REMARKS

Serial No. 10/635,644  
Amdt. filed 11/24/04  
OA dated 8/24/04

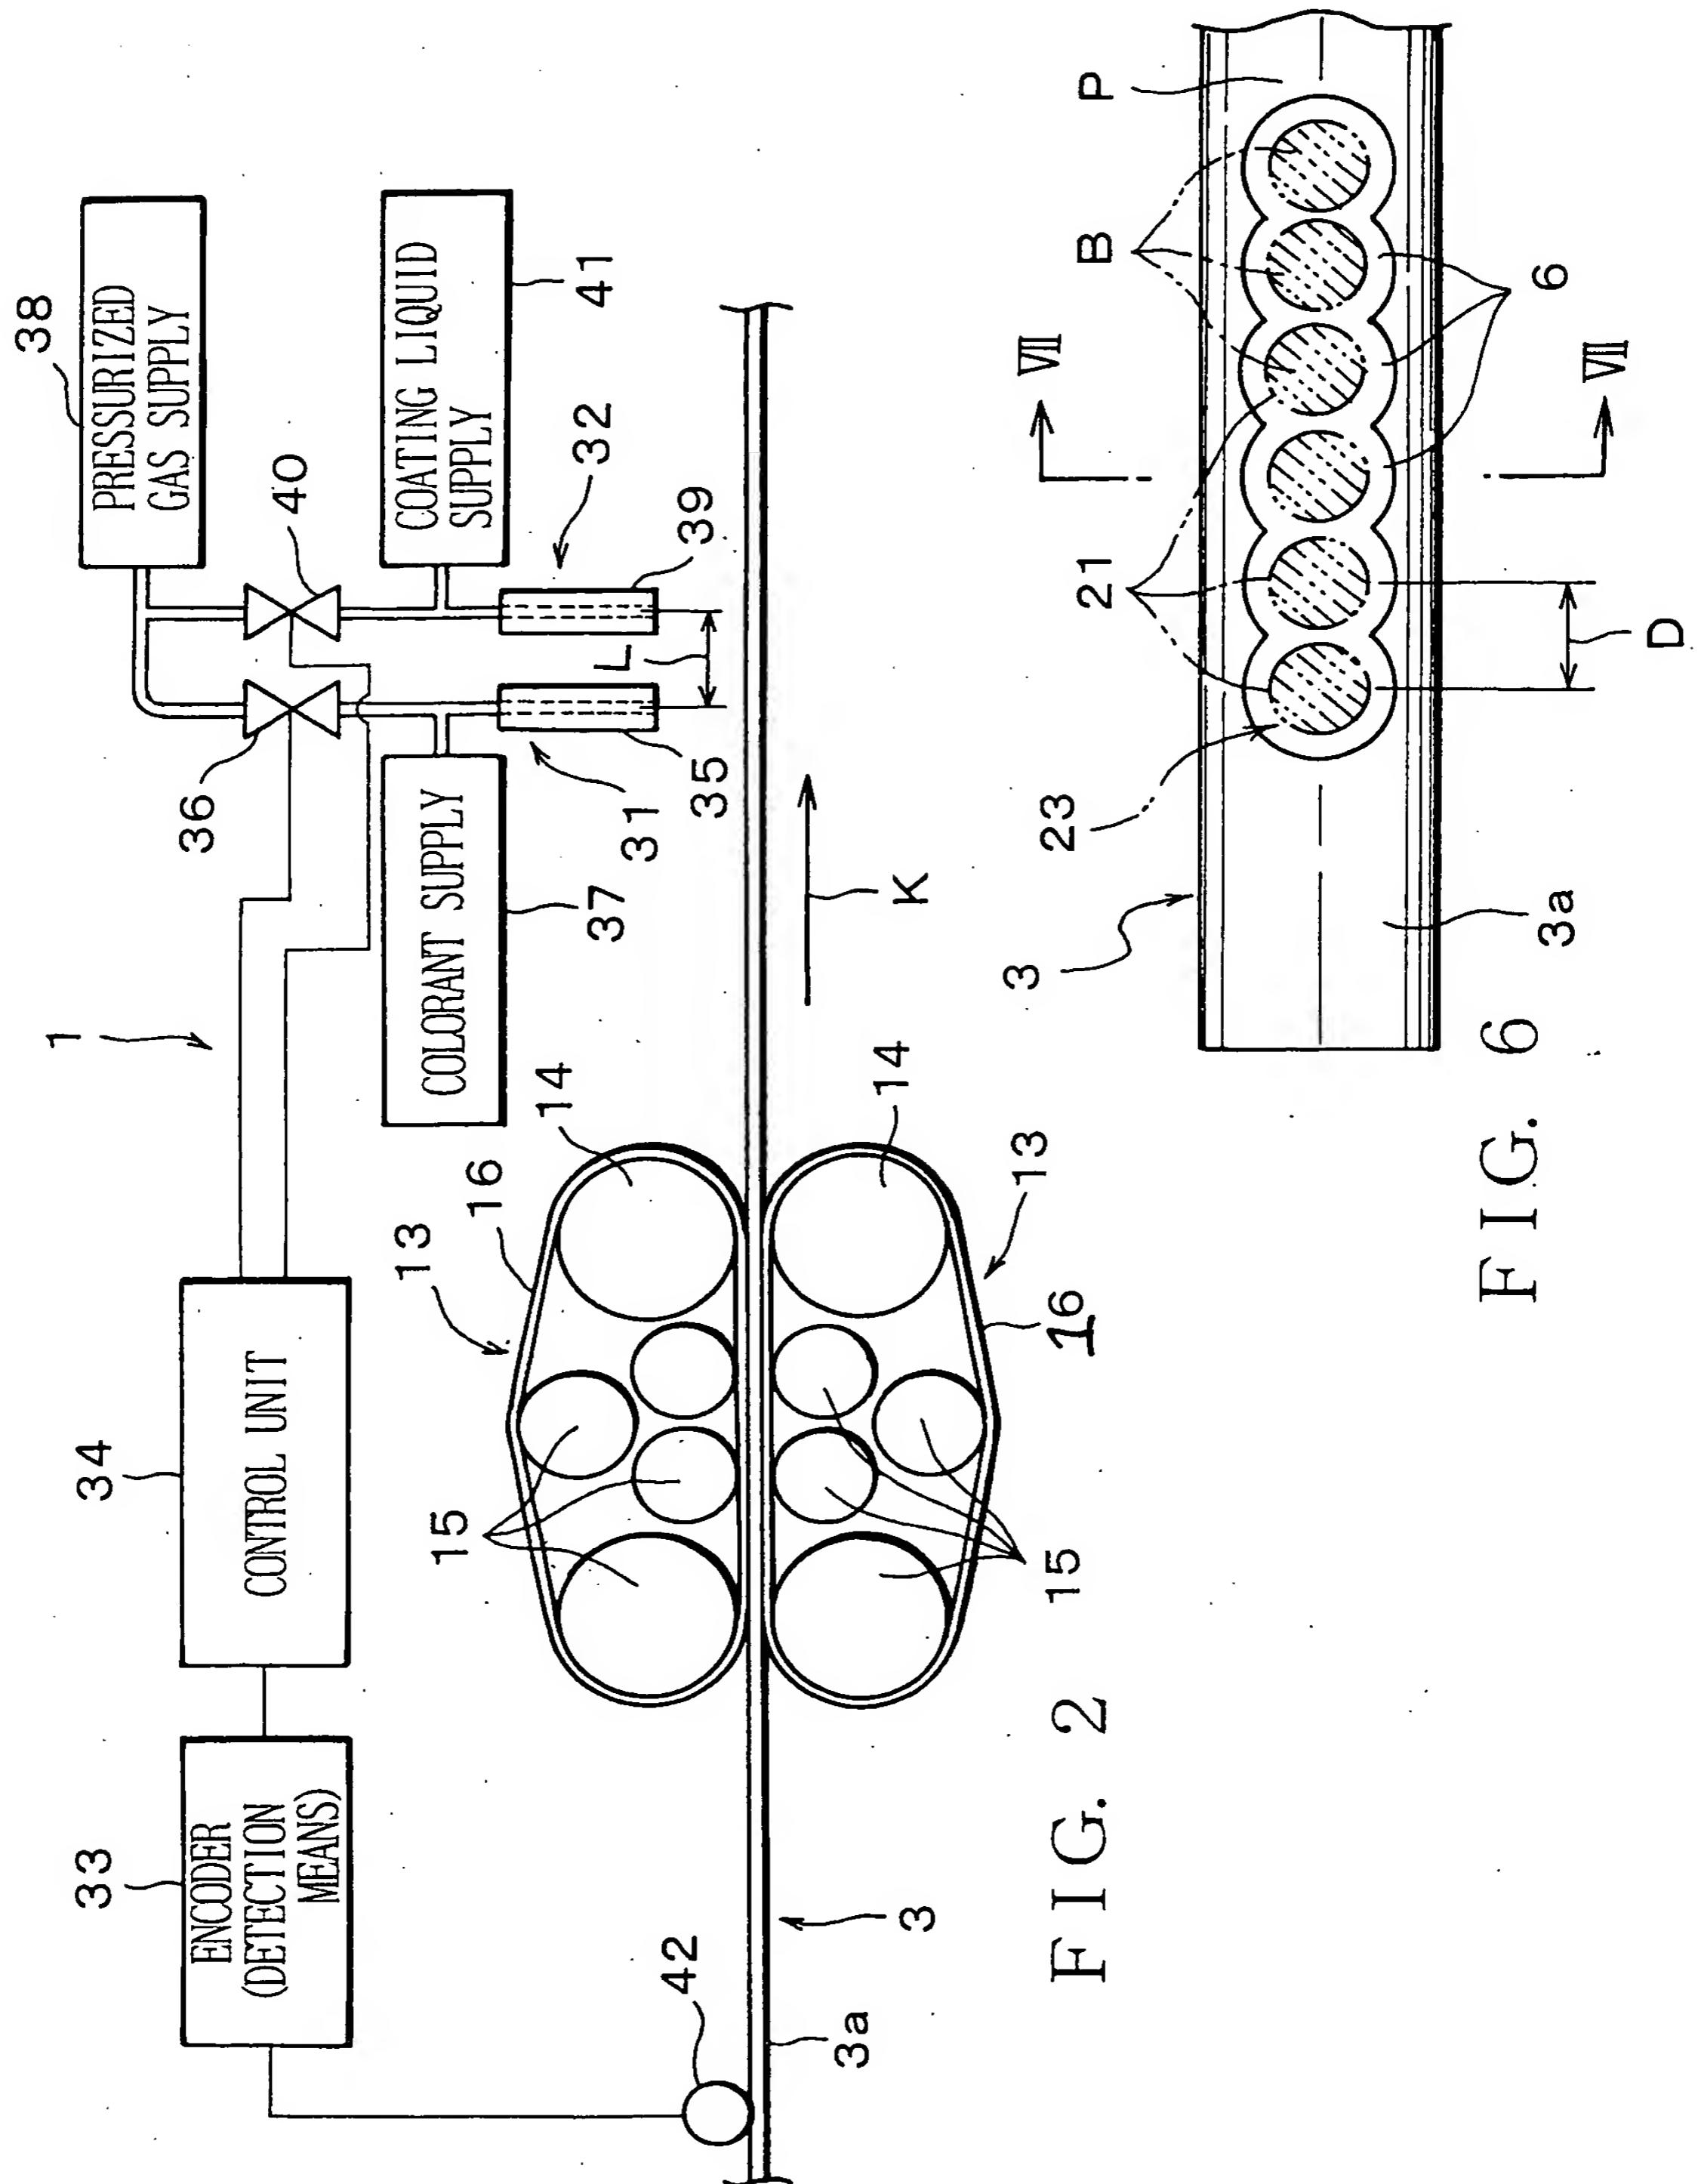
The drawings were objected to as failing to comply with 37 C.F.R. §1.84(p)(4) because reference character "6" was used to designate both the coating layer and the endless belt (in Figure 2). Corrected drawing sheets in compliance with 37 C.F.R. §1.121(d) were required in reply to the Office Action to avoid abandonment of the application.

In response, accompanying this Amendment is a revised Figure 2 where the reference numeral "6" has been changed to "16" to be in conformity with page ten of the

subject specification. Withdrawal of the objection is therefore requested.

In Figure 2, reference numeral "6" has been changed to reference numeral -16-.

FIG. 4

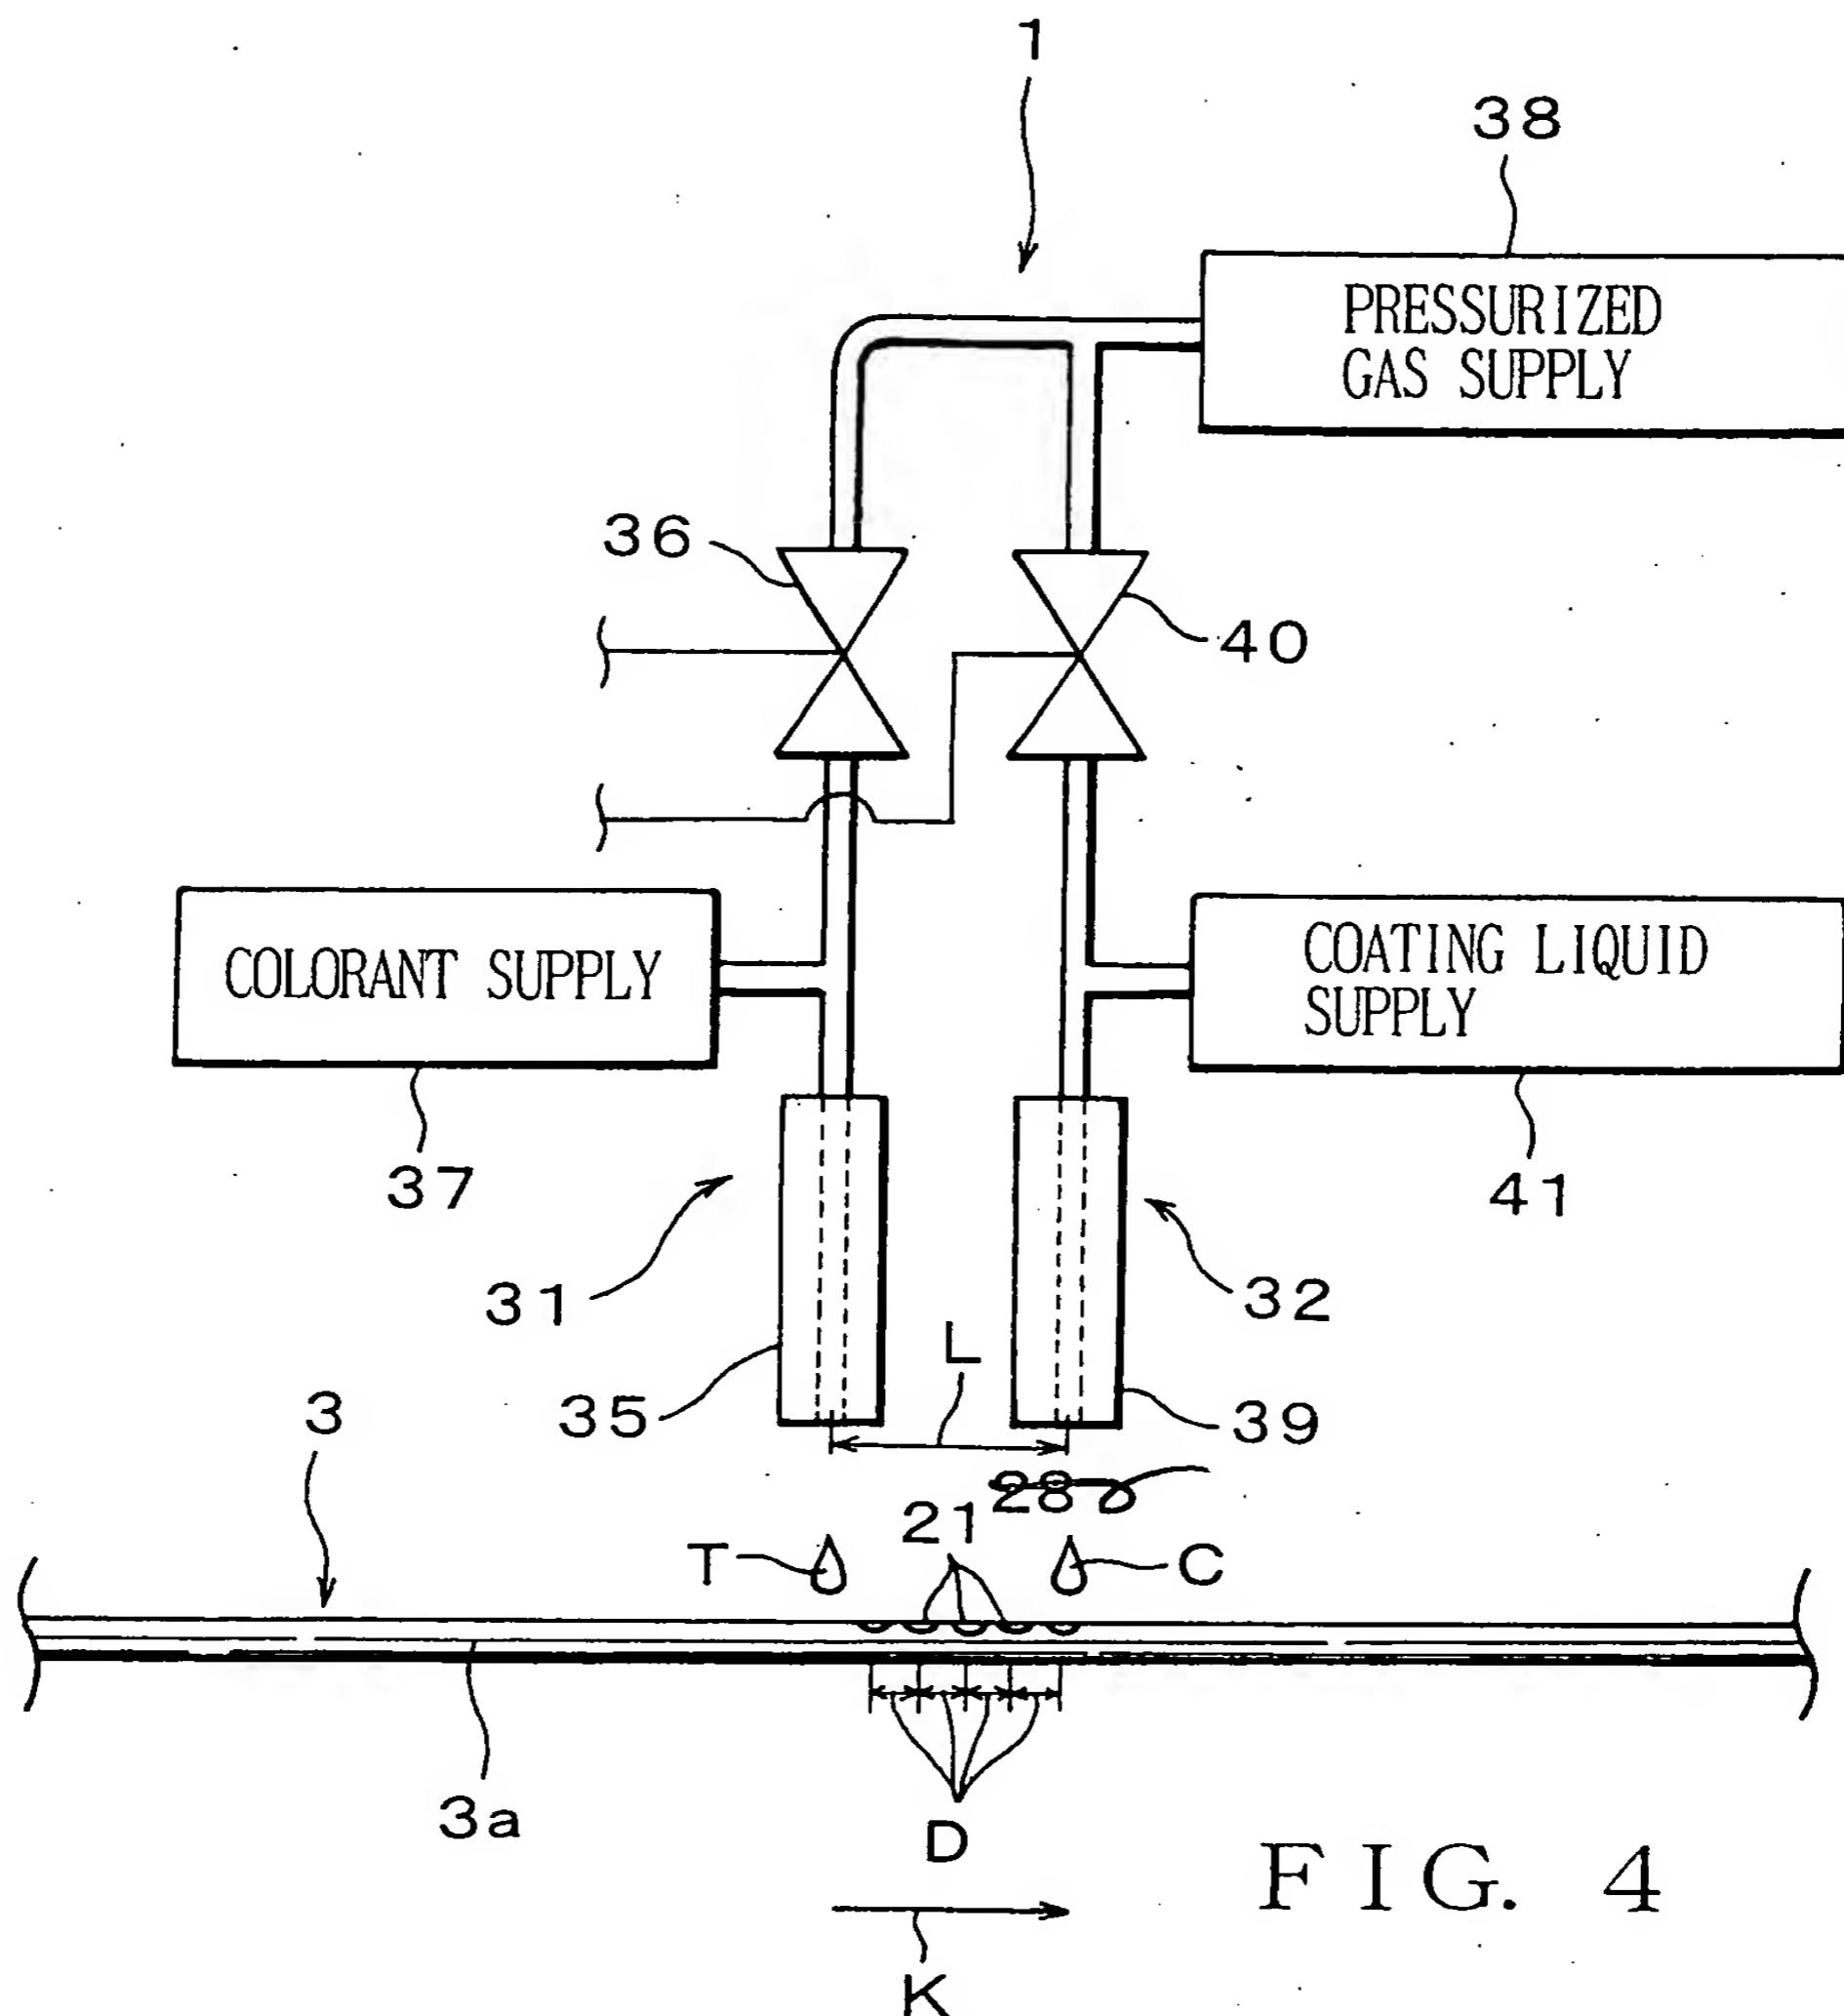
The drawings also were objected to as failing to comply with 37 C.F.R. §1.84(p)(5) because they included the following reference character(s) not mentioned in the description: 28. Corrected drawings sheets in compliance with 37 C.F.R. § 1.121(d) or amendment to the specification to add the reference character(s) in the description in compliance with 37 C.F.R. 1.121(b) were required in reply to the Office Action to avoid abandonment of the application.

In response, accompanying this Amendment is a revised Figure 4 where the reference numeral "28" has been deleted. Withdrawal of the objection is therefore requested.

In Figure 4, reference numeral "28" has been deleted.
